EPA Reference: 2285

Site Address: 55-61 Molesworth
Street, Wellington

Fast-track Consenting - Molesworth Street Office Development Application Heritage Review

Image 2: WCC site levels drawing c.1960s

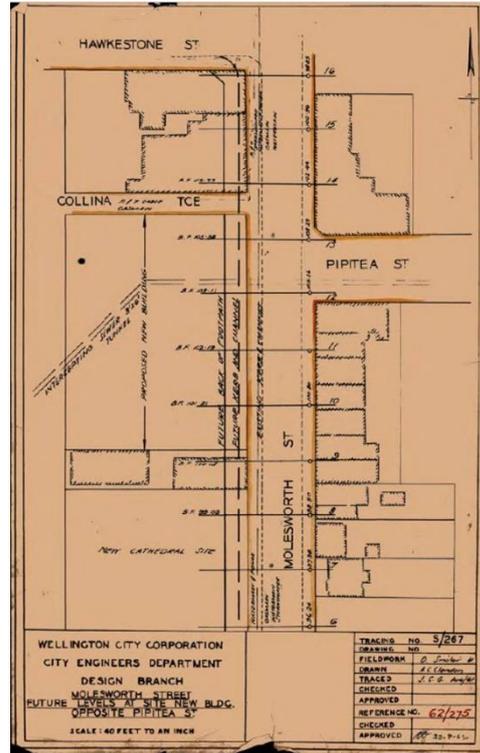
- 7.7. I have discussed the sewerage interceptor with Wellington City Council (WCC), and their asset data notes that this section was constructed in 1937 from reinforced concrete and is 1.25m in diameter - see image 1 below. There is also some earlier information from the 1960s to suggest that the interceptor may be a 3ft x 6ft tunnel – see the WCC City Engineers’ Department drawing in image 2 below, but there is no notation on this drawing to indicate whether it is brick or reinforced concrete.

This 1960s drawing refers to the sewerage interceptor as a 3' x 6' tunnel.

Image 3: Thomas Ward Map

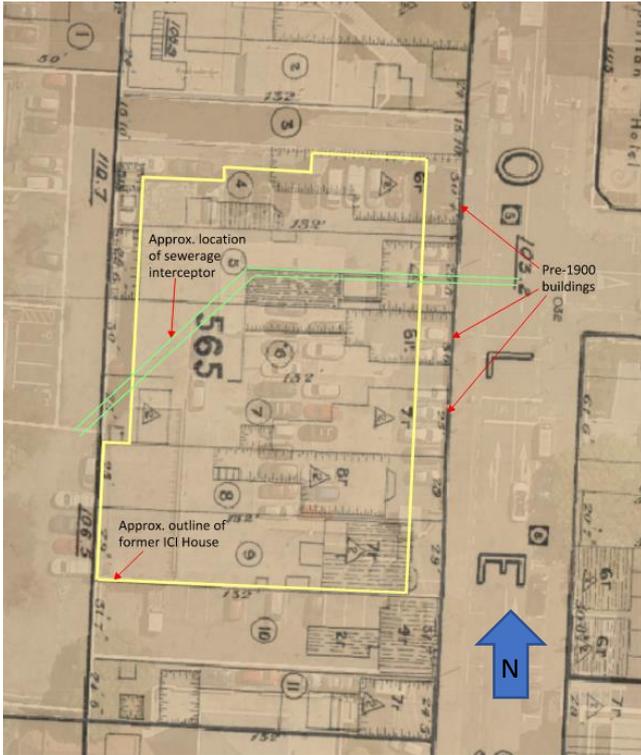
The c.1892 Thomas Ward map shows the extent of known pre-1900 buildings on the site at 55-61 Molesworth Street. This has been overlaid with the approx. location of ICI House to show any locations where the ground may not have been excavated for the foundations of the previous building.

Image 4: Excavation Plan for ICI House.

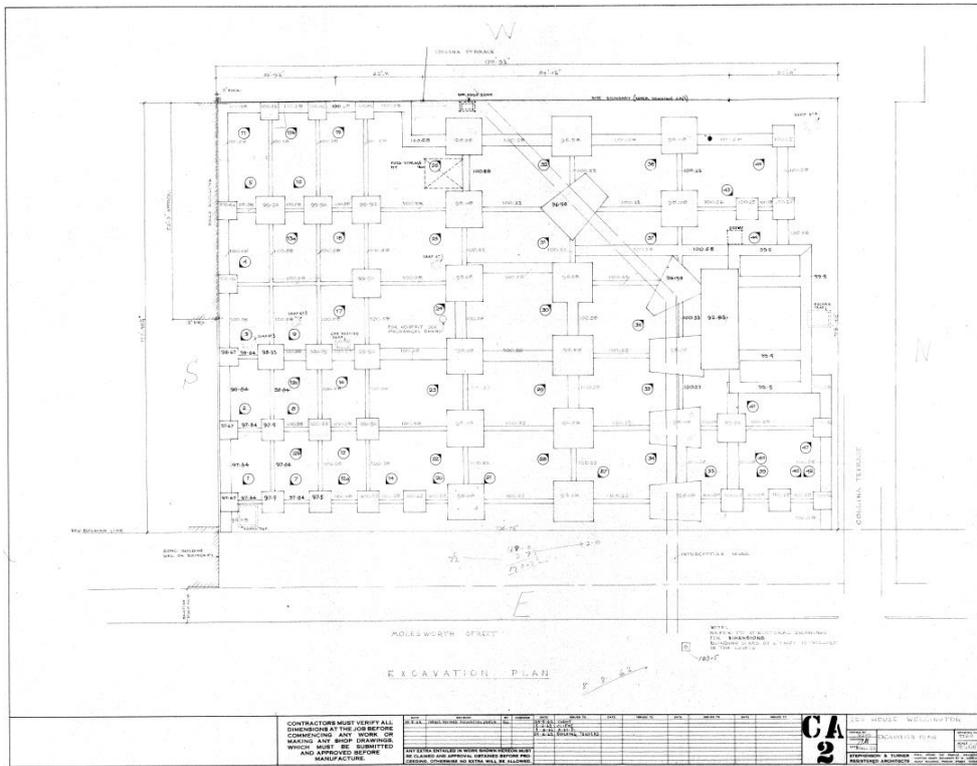
7.12. Image 4 below shows the ground floor foundation layout for the former ICI House that was constructed in the 1960s. Note that this building was constructed with a set-back from Molesworth Street to the east of the site, and did not include a basement. The “set-back” area to the east is the location that is likely to have experienced the least ground disturbance during the construction of ICI House.
